DA Access Report

21330

Chisholm Shopping Centre
Heritage Drive, Chisholm, NSW

ACCESS REPORT

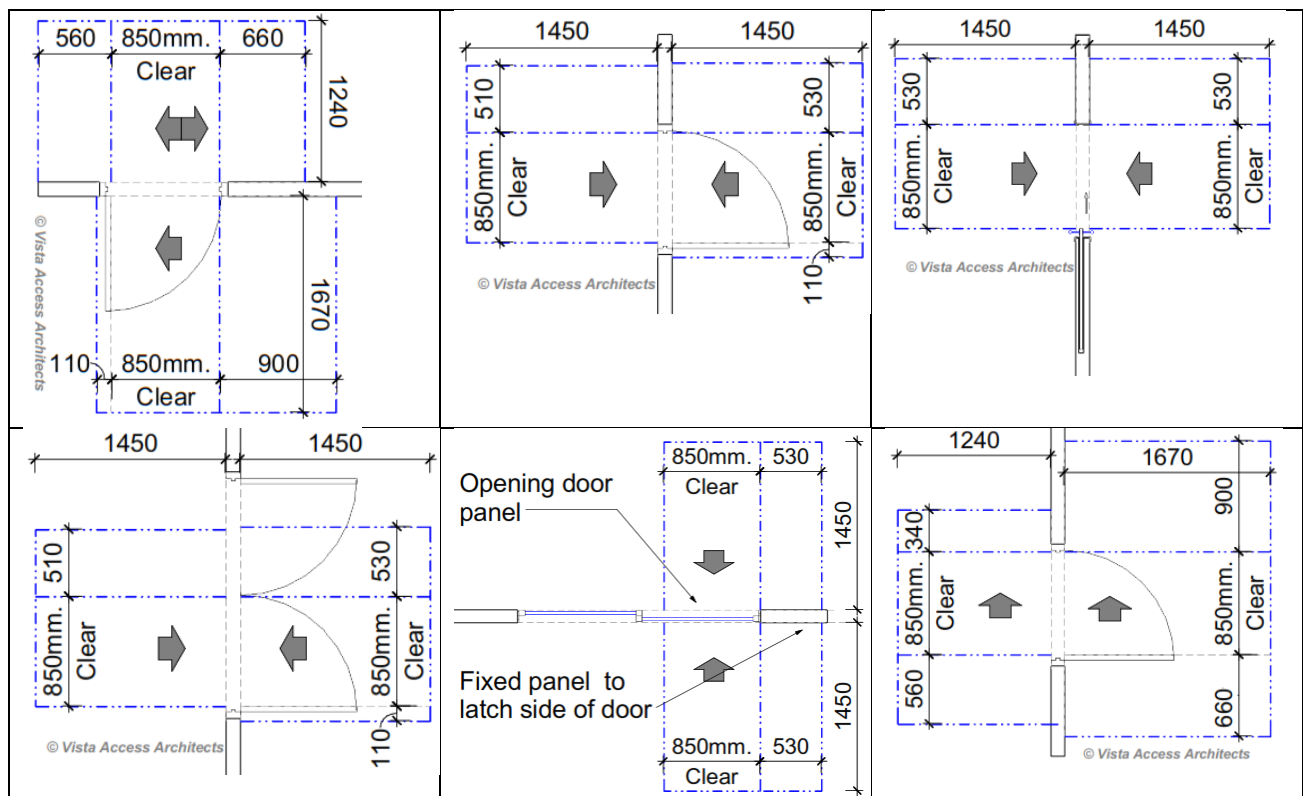
The following is required at CC stage:

A step free entry is to be detailed from the site boundary to entry lobby. RLs are not noted and therefore compliance cannot be verified.

All curved pathway to be minimum 1500mm wide

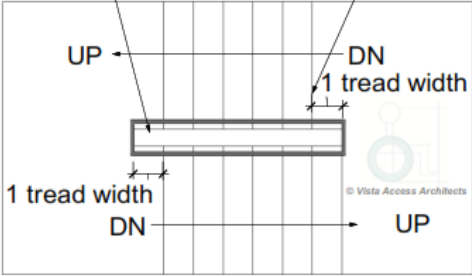
The following will be required at CC stage of works.

- 1:14 ramp to start at sharp 90 degree to direction of travel.
- 1:14 ramp to start at min 900mm from site boundary
- Mid landing at u turn to have a clear space of 1540x2070 at mid landing

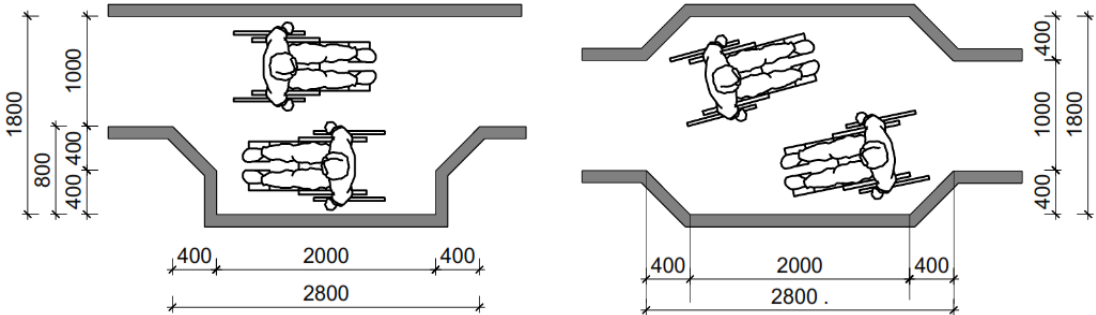
- 1:19 grade is considered to be a ramp and not a walkway.
- Ramp to start at min 900mm from site boundary
 - Ramp to allow for 300mm handrail extensions.
